ADDENDUM #1

Reference: UVSC – Heat Plant Waterproofing & Remodel
Utah Valley State College
Project Number 06311790

**UTAH VALLEY STATE COLLEGE
HEAT PLANT PLAZA IMPROVEMENTS
D.F.C.M. PROJECT #06311790**

ADDENDUM NO. 1

AE-102r1

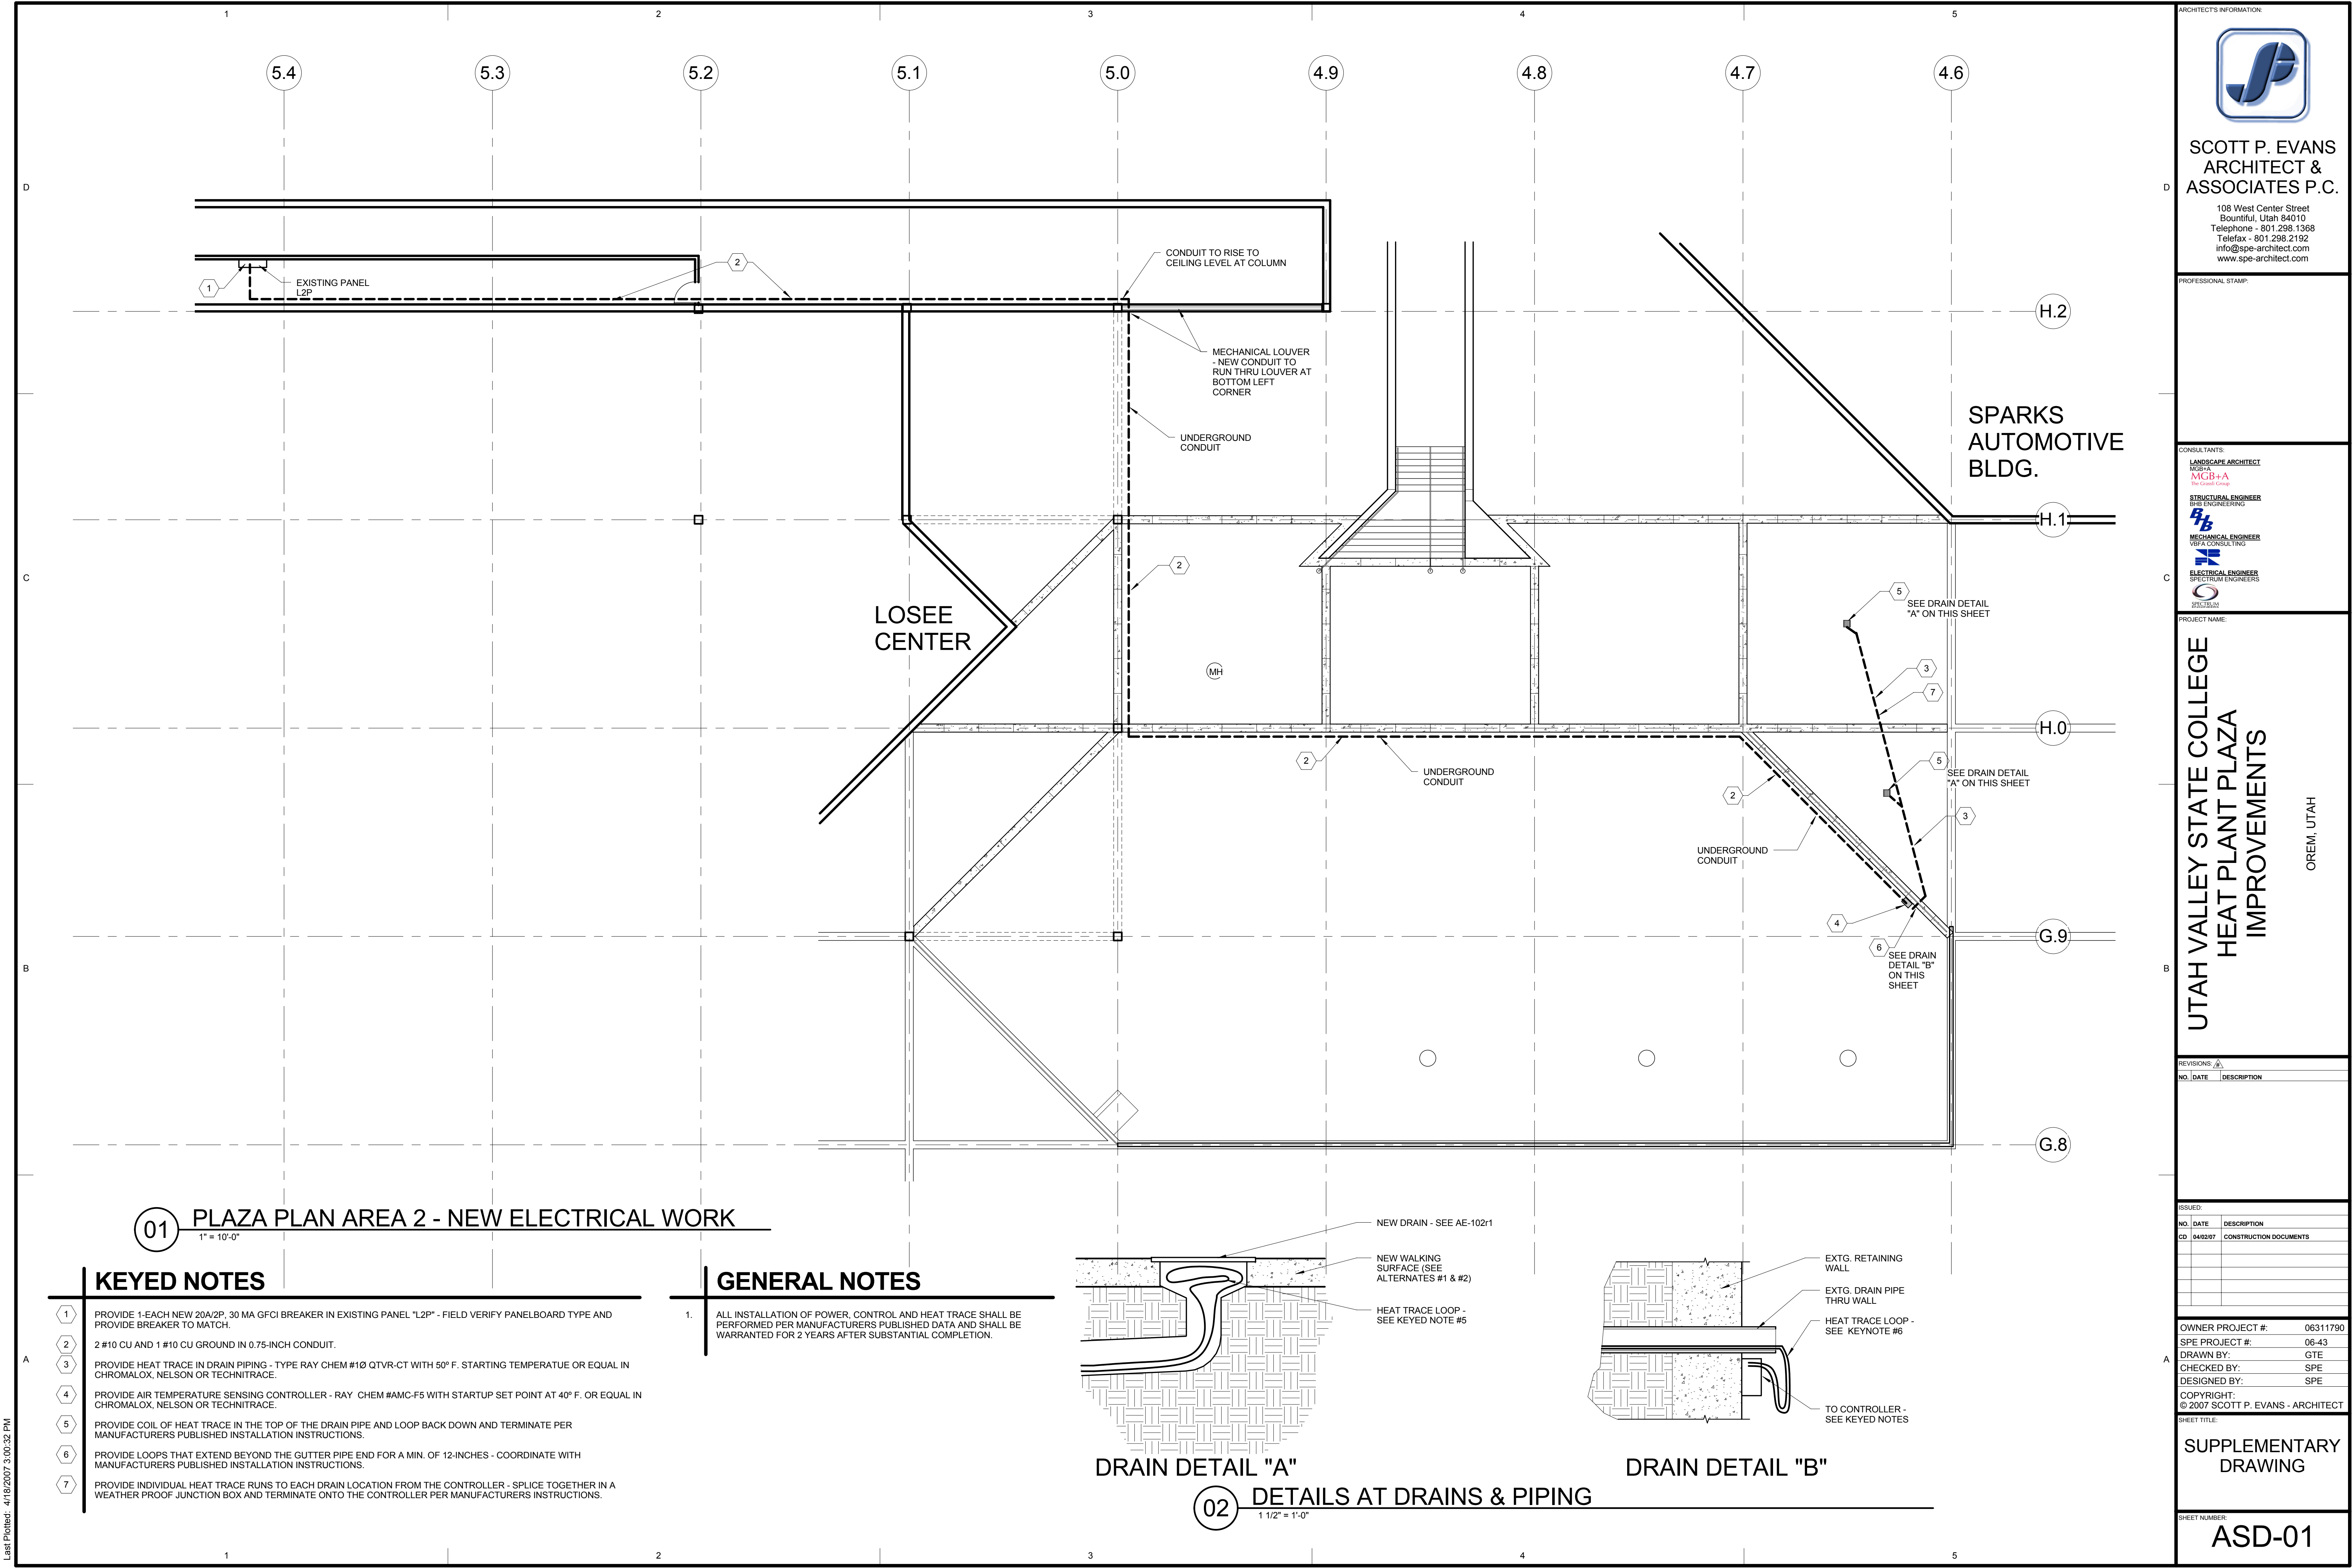
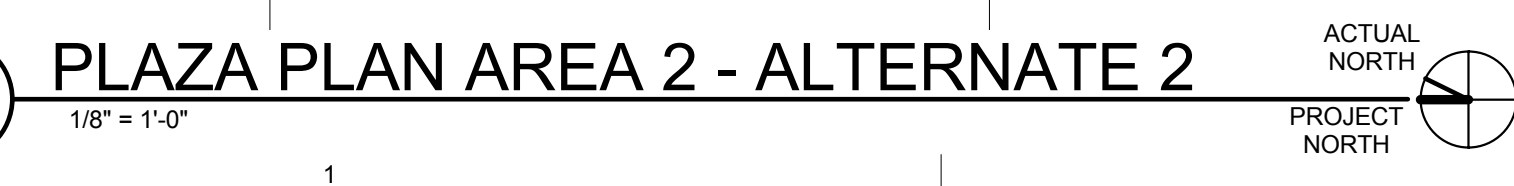
Replace sheet AE-102 from the original construction documents with the revised sheet AE-102r1 attached to this document. The changes to this sheet include the following:

- Removal of existing plaza drains and the installation of new drains (relocated) to be tied into existing drain piping that daylight through the adjacent concrete wall.
- New conduit, conductors, controls, and heat tape etc. for the new drain lines.
- Removal of sand base beneath the asphalt pavers in Alternate #1.
- Change of the concrete joint pattern on Alternate #2 from a 5'-0" square pattern to a 10'-0" square pattern (still on campus grid).

- EXISTING PRECAST CONCRETE FEATURE STRIP TO REMAIN.
- NEW PRECAST CONCRETE FEATURE STRIP - 2 1/2" THICK, 1'-2" WIDE AND 60" LONG - JOINTS ARE TO ALIGN WITH CAMPUS GRID SYSTEM - SET ON 2" SAND BED - PROVIDE #2 BAR LOOPS (2 PER 5' SECTION) DRILLED AND EPOXIED INTO NEW CONCRETE BASE - PROVIDE HOLES/CHANNELS IN BOTTOM OF PRECAST STRIPS ALONG GRID H.0 FROM GRIDS 4.7 TO 5.1 TO ALLOW WATER DRAINAGE BENEATH THE PAVERS ONTO THE GRASS.
- EXISTING ASPHALT PAVER SYSTEM TO REMAIN - PROTECT FROM DAMAGE.
- EXISTING LAWN / LANDSCAPING - PROTECT FROM DAMAGE - REWORK / MODIFY EDGES AFFECTED BY NEW WORK.
- NEW PLAZA DRAIN SYSTEM - SLOPE NEW WALKING SURFACE IN THIS AREA TO DRAIN - INSTALL PER THE FOLLOWING:

Alternate #1:
Install new drain, DD-3, connect new drain piping to existing piping. See plumbing specifications for fixture specification.

Alternate #2:
Install new drain, DD-3, remove perforated extension on drain body for installation in slab on grade. Connect new drain piping to existing piping. See plumbing specifications for fixture specification.

- NEW PRECAST CONCRETE WALL CAP - SIM. TO C3/AE-501 - F.V. JOINT LOCATIONS TO WORK WITH EXISTING RAILING POSTS.
- NEW CONDUIT, WIRING, CONTROLS ETC. TO SUPPORT NEW HEAT TAPE THAT IS TO BE INSTALLED IN THE DRAIN LINES - SEE SUPPLEMENTARY DRAWING ASD-01.

- DRAIN PIPING UNDERGROUND - TIE NEW PIPING INTO EXISTING AS REQUIRED - EXISTING PIPE DAYLIGHTS THRU FACE OF CONCRETE WALL - PROVIDE NEW HEAT TAPE IN DRAIN LINES - SEE SUPPLEMENTARY DRAWING ASD-01.

ASD-01

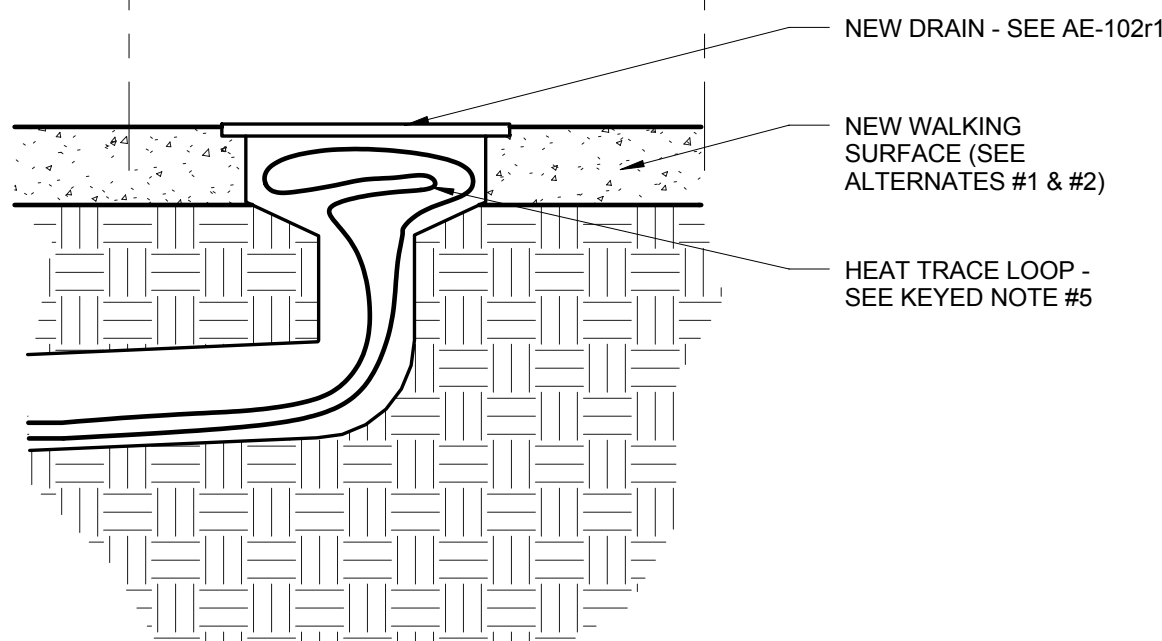
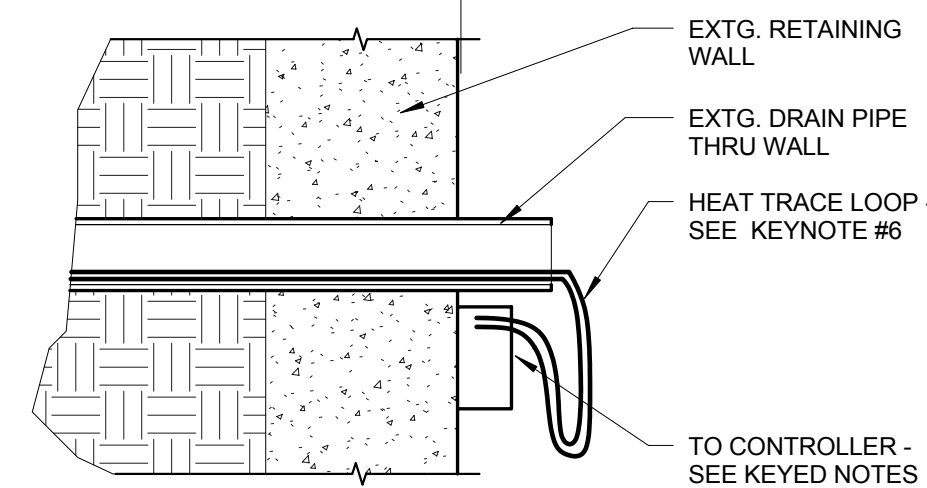
- Please find Supplementary Drawing ASD-01 attached to this document. This drawing covers the new electrical work that is to take place in area #2 if alternates #1 or #2 are accepted.

- 1 PROVIDE 1-EACH NEW 20A/2P, 30 MA GFCI BREAKER IN EXISTING PANEL "L2P" - FIELD VERIFY PANELBOARD TYPE AND PROVIDE BREAKER TO MATCH.
- 2 2 #10 CU AND 1 #10 CU GROUND IN 0.75-INCH CONDUIT.

- 3 PROVIDE HEAT TRACE IN DRAIN PIPING - TYPE RAY CHEM #10 QTVR-CT WITH 50° F. STARTING TEMPERATUE OR EQUAL IN CHROMALOX, NELSON OR TECHNITRACE.
- 4 PROVIDE AIR TEMPERATURE SENSING CONTROLLER - RAY CHEM #AMC-F5 WITH STARTUP SET POINT AT 40° F. OR EQUAL IN CHROMALOX, NELSON OR TECHNITRACE.

- 5 PROVIDE COIL OF HEAT TRACE IN THE TOP OF THE DRAIN PIPE AND LOOP BACK DOWN AND TERMINATE PER MANUFACTURERS PUBLISHED INSTALLATION INSTRUCTIONS.
- 6 PROVIDE LOOPS THAT EXTEND BEYOND THE GUTTER PIPE END FOR A MIN. OF 12-INCHES - COORDINATE WITH MANUFACTURERS PUBLISHED INSTALLATION INSTRUCTIONS.

- 7 PROVIDE INDIVIDUAL HEAT TRACE RUNS TO EACH DRAIN LOCATION FROM THE CONTROLLER - SPLICE TOGETHER IN A WEATHER PROOF JUNCTION BOX AND TERMINATE ONTO THE CONTROLLER PER MANUFACTURERS INSTRUCTIONS.
